ADDENDUM NO. 1

ISSUE DATE: April 4, 2018

CRC College Center Expansion

LRCCD BID NO. 17021

WALL SECTION AT LOBBY - WEST
1 1/2" = 1'-0" K8

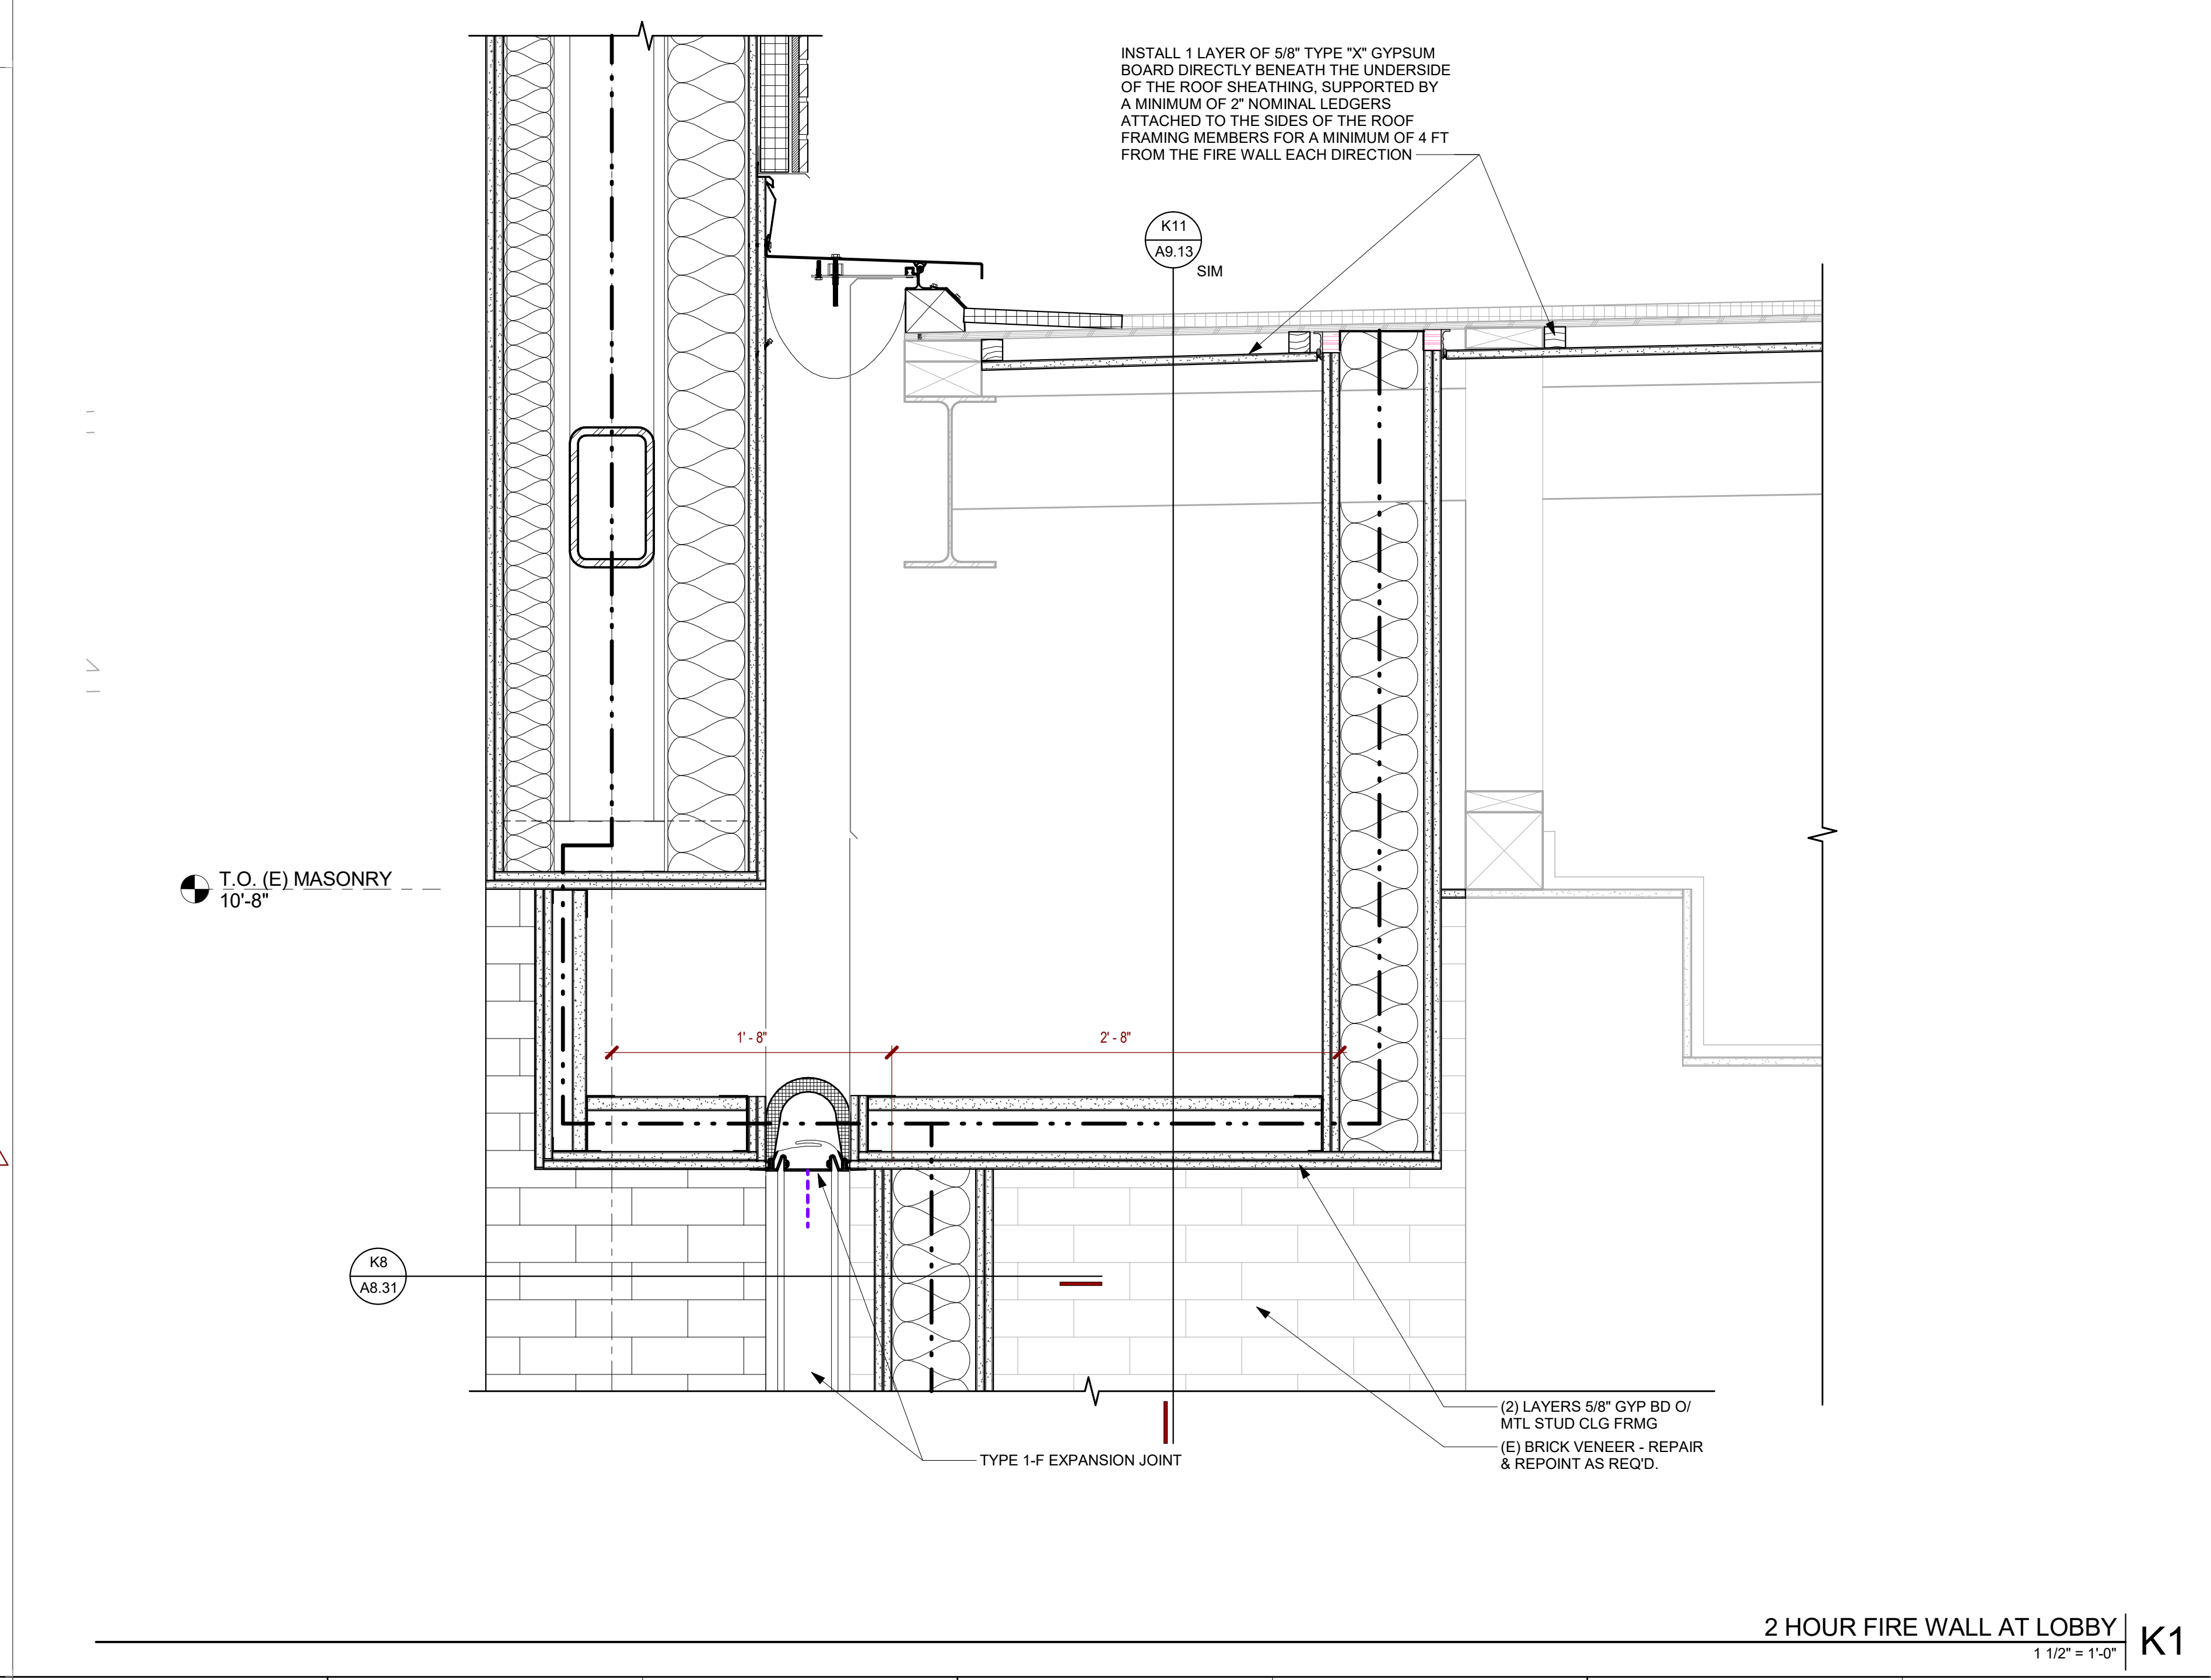
- A8.34 – Added detail G4
- A9.10 – Modified detail K8 and E8
- A9.11 – Modified detail F10 & H5. Removed detail F5
- A9.12 – Modified detail H3, H6, F8, F10, D8 and D10

SHEET NO:
P3.01

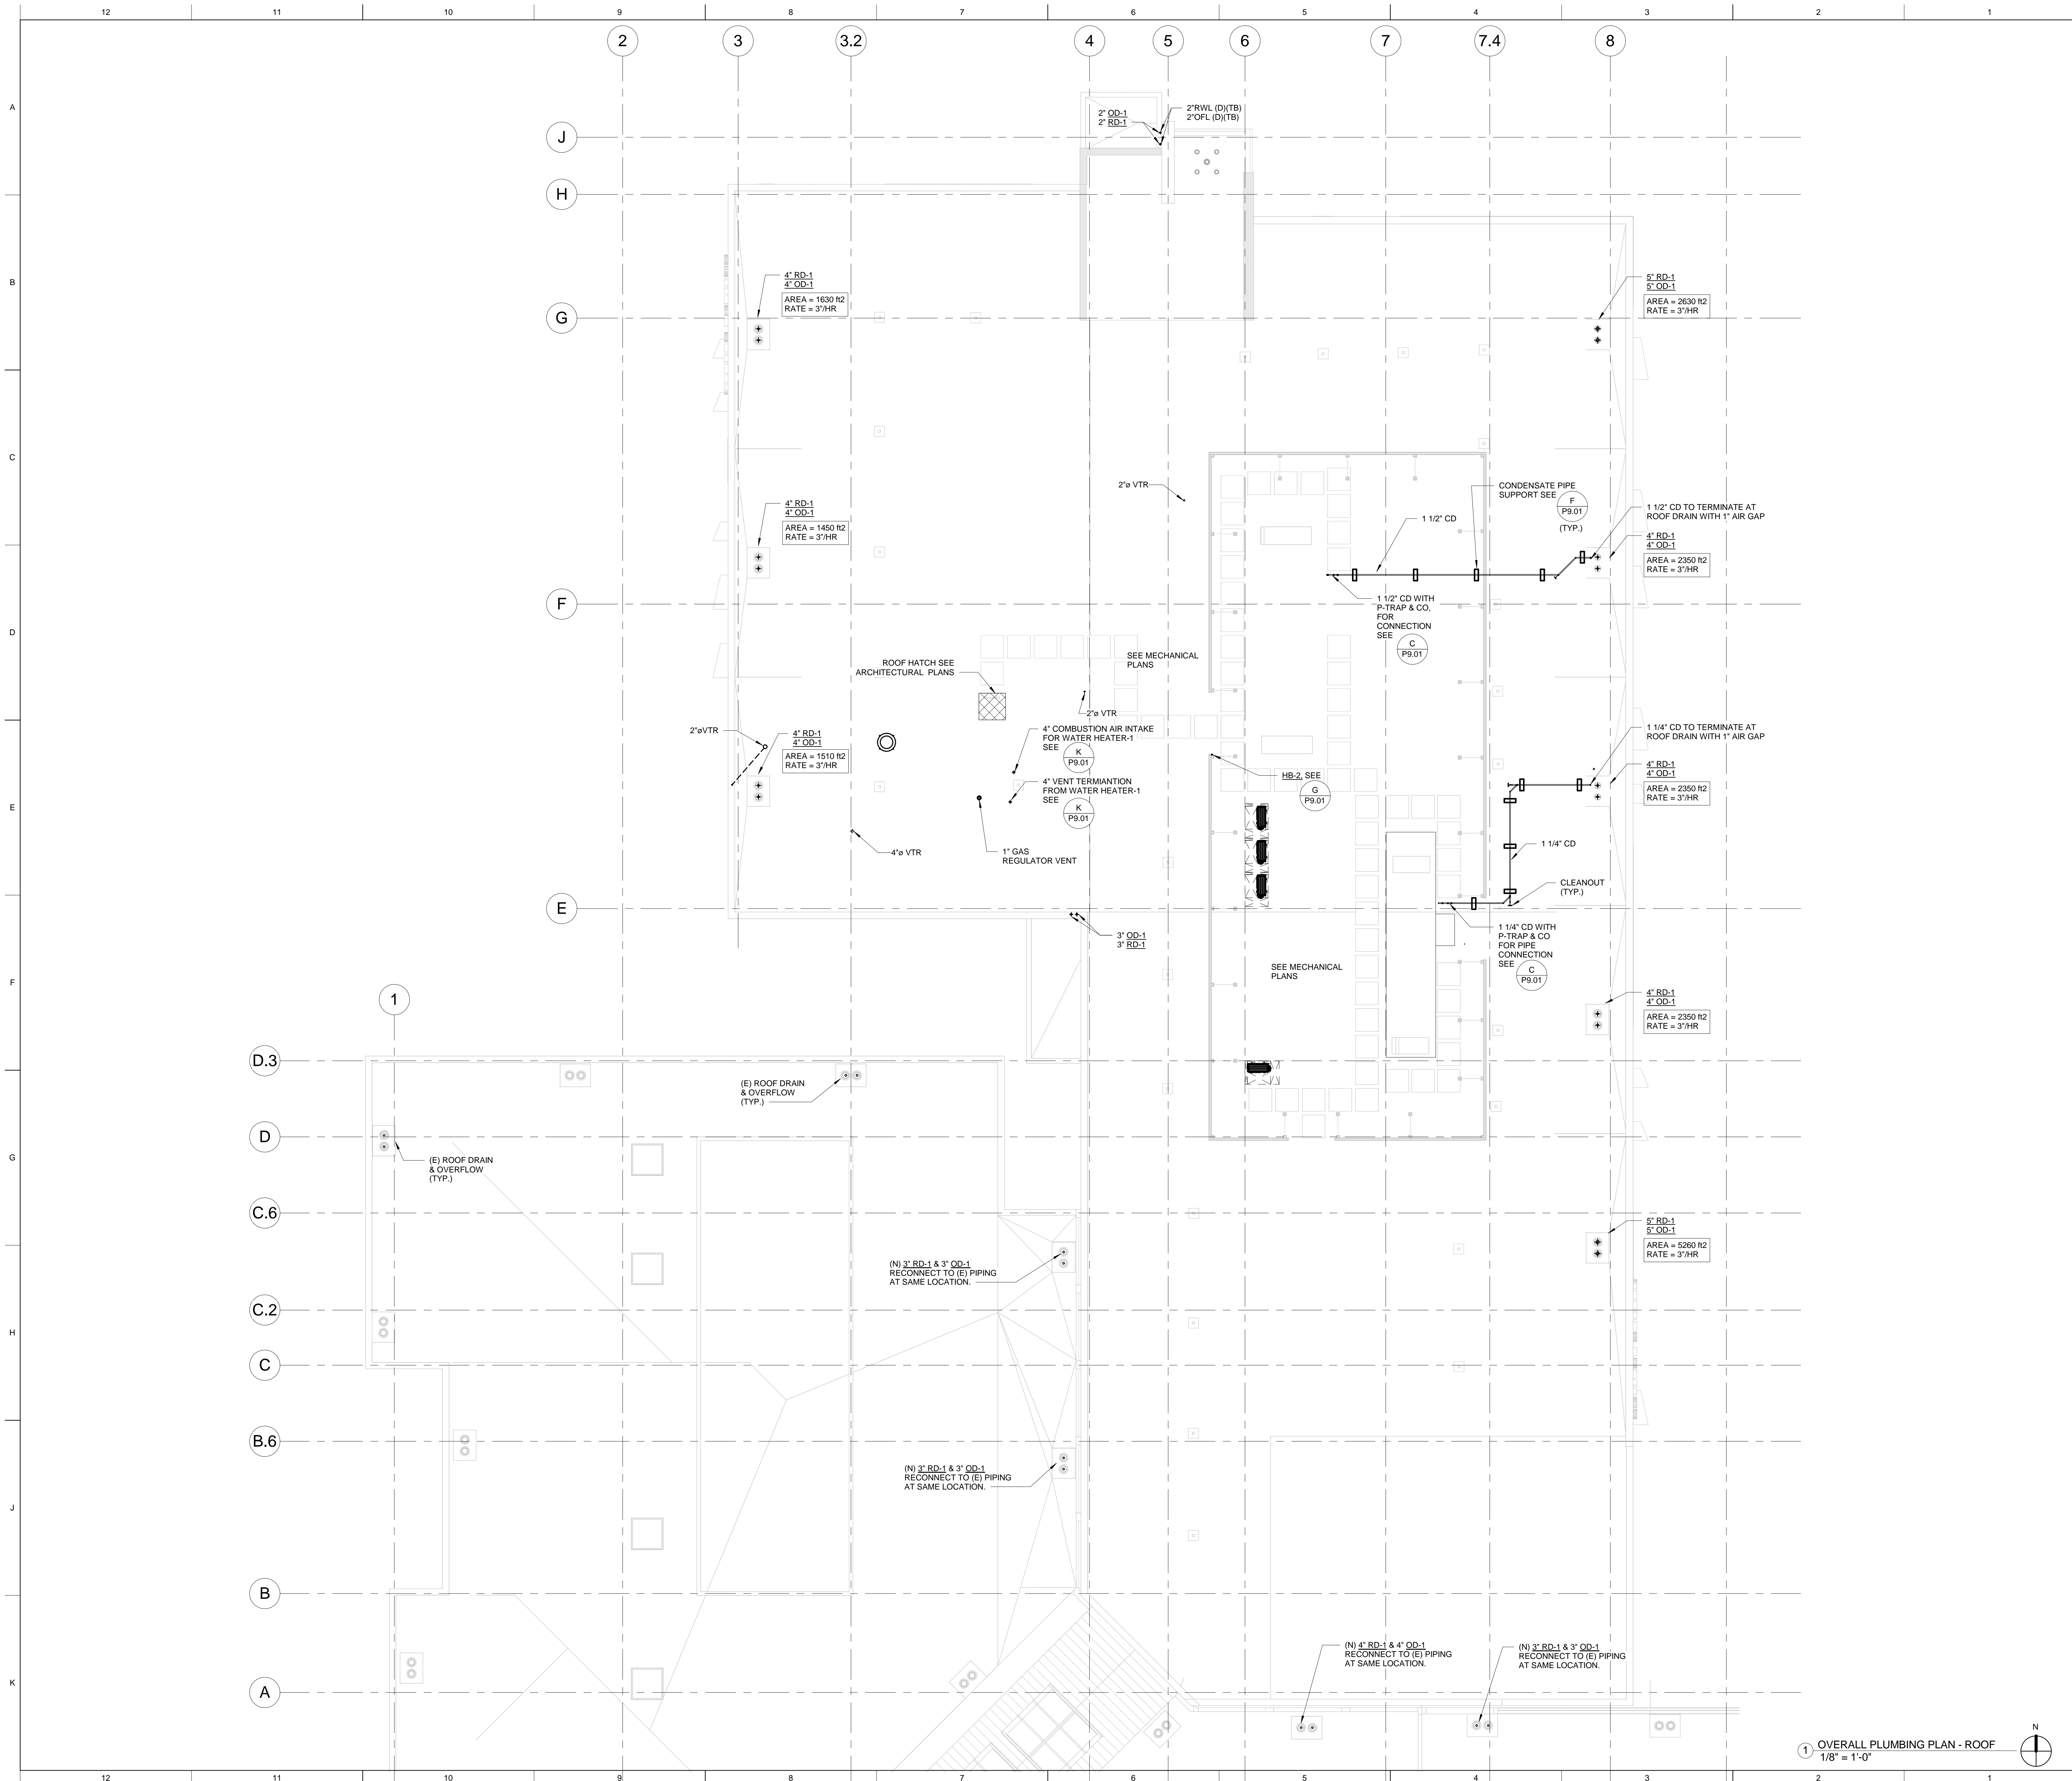
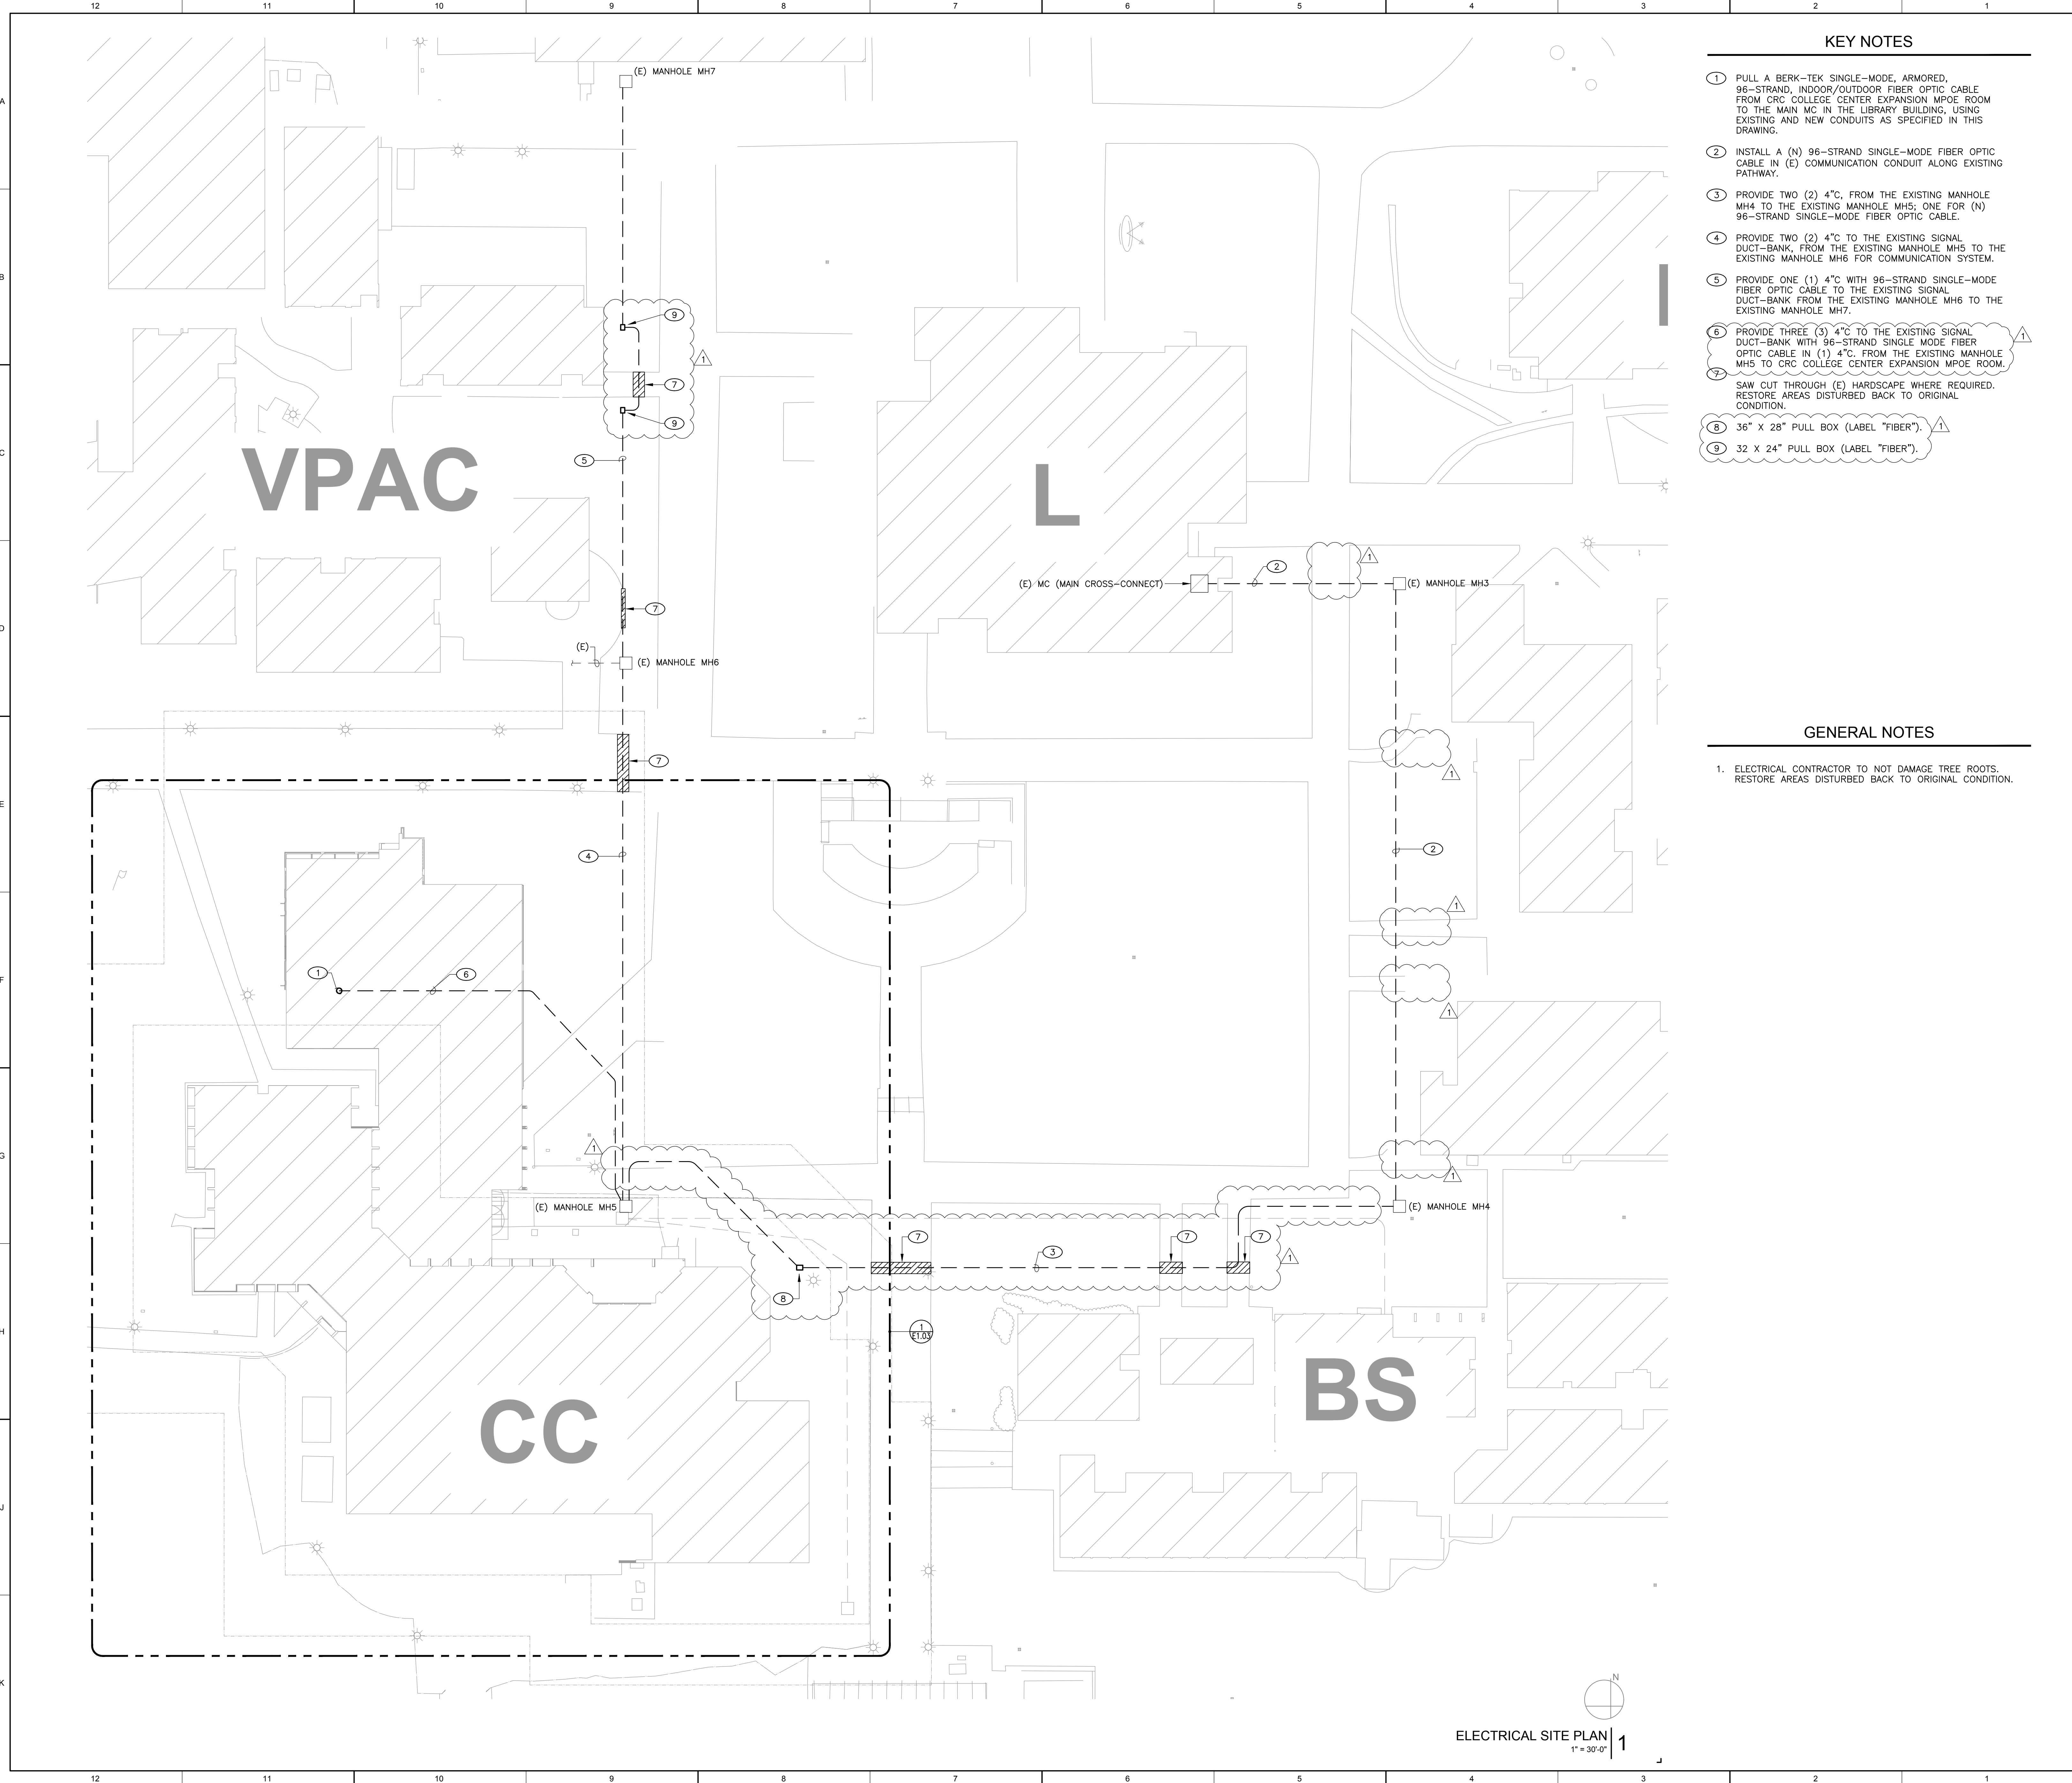
- P2.06 – Updated the sheet to add the new sink at open office 130
- P2.07 – Updated the sheet to add the new sink at open office 130
- P3.01 – Added sheet
